GLID as Envelope ID – a Deeper Look

Glen Kramer, Broadcom

IEEE 802.3ca 100G-EPON

Traffic burstiness

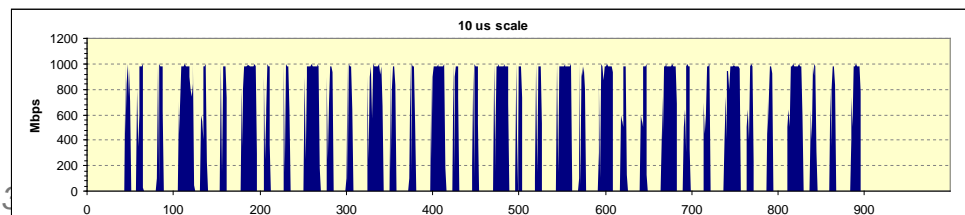
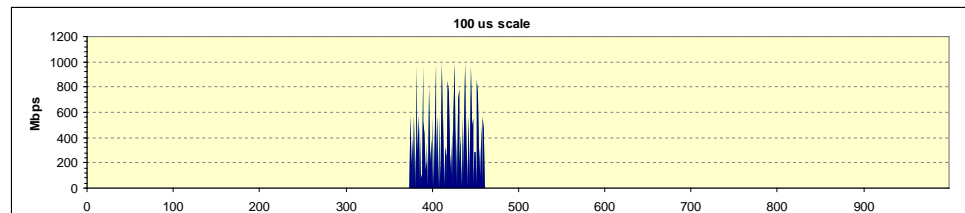
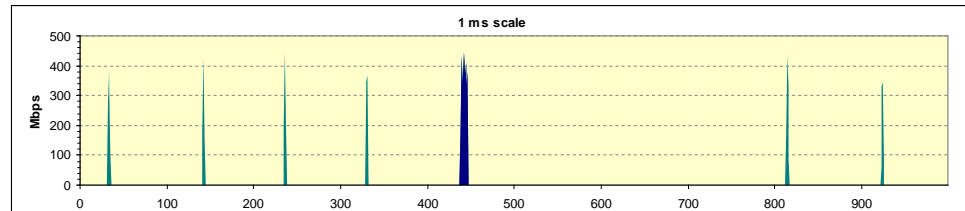
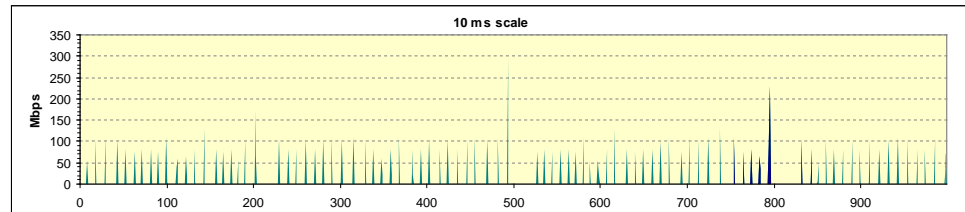
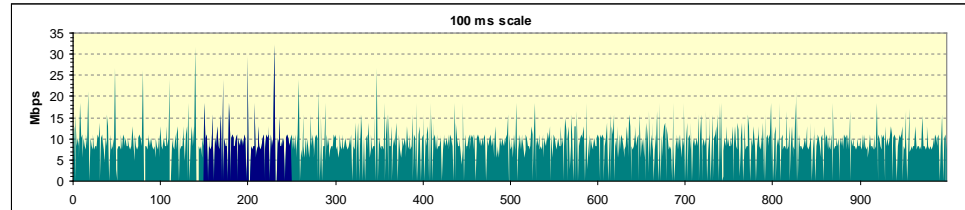
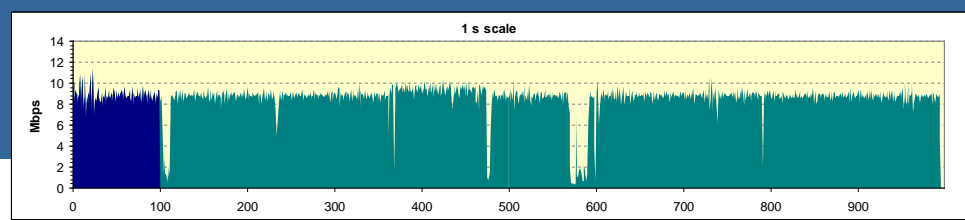
- ❑ Traffic is bursty at many timescales – microseconds to hours.
- ❑ Even single flows are bursty on sub-RTT timescales (see caida.org/workshops/isma/0411/slides/dovrolis.ppt)
- ❑ This means that if a frame belongs to a flow A, the next received frame is much more likely to belong to the same flow A, and not to another flow B.

Envelope Header Overhead

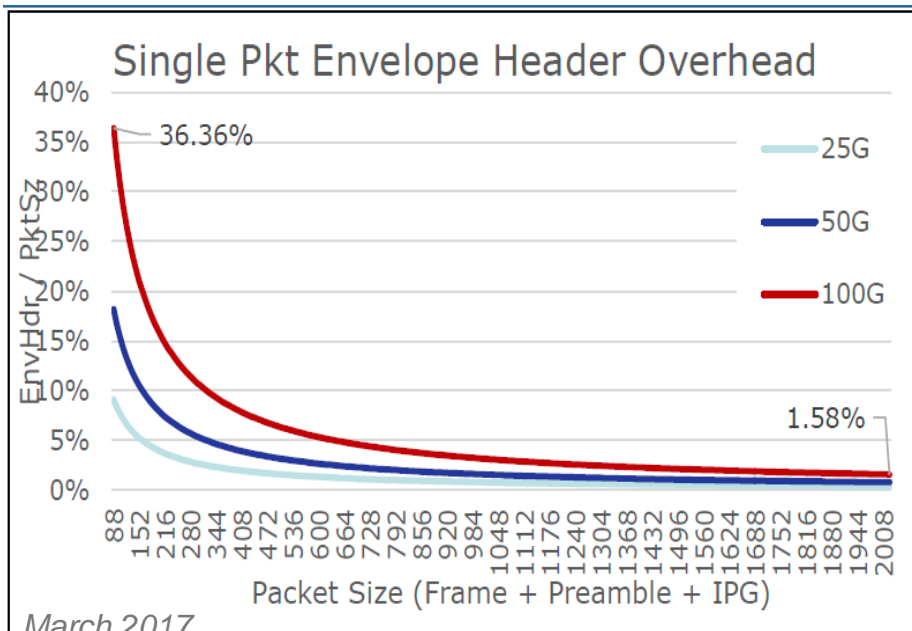
- ❑ This chart shows Envelope Header Overhead under the following conditions:
 1. All packets are of same size (starting with all 64-byte packets)
 2. Every packet goes to a different LLID (every envelope contains a single packet)

3. Every packet to 100G ONU is split over 4 wavelength
- ❑ These are not realistic conditions and they cannot happen all at once.
- ❑ Packets usually arrive in bursts, so there are usually multiple packets that can go in each envelope.

- ❑ If multiple LLIDs all have a single packet to transmit, then up to 4 LLIDs can transmit in parallel on 4 wavelengths – no need ever to split across wavelengths.

- ❑ The 36% overhead is not possible, unless OLT deliberately tries to self-sabotage.
 - The same self-sabotage is possible in XG-PON, because XGEM header is 8 bytes and the minimal XGEM Payload Length is 1 byte (but it is rounded up to 4 bytes). So, the worst case overhead is 91.7%. But it has never been considered a problem because devices do not deliberately sabotage their performance.
